REWORK RW#1 - 19.11.2019 - PCB 018/00

REWORK RW#2 - 01.06.2020 - PCB 018/00

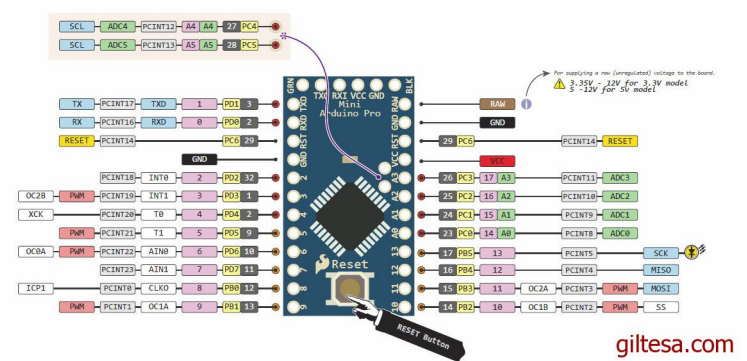
for arduino compatibility of WS2811 control:

- use pin PB1 (Arduino: D1) instead of PB7
- do not populate R11
- do not populate Q1/R5

to get the firmware update via UART running correct:

- use 0-Ohm for R10 (TXD)

to get the remote control running with R10 set to 0-Ohm:

- use PC4 (Arduino: A4) for RC analog input
- set PD0 (Arduino: D0) high, to use R9 as pull-up
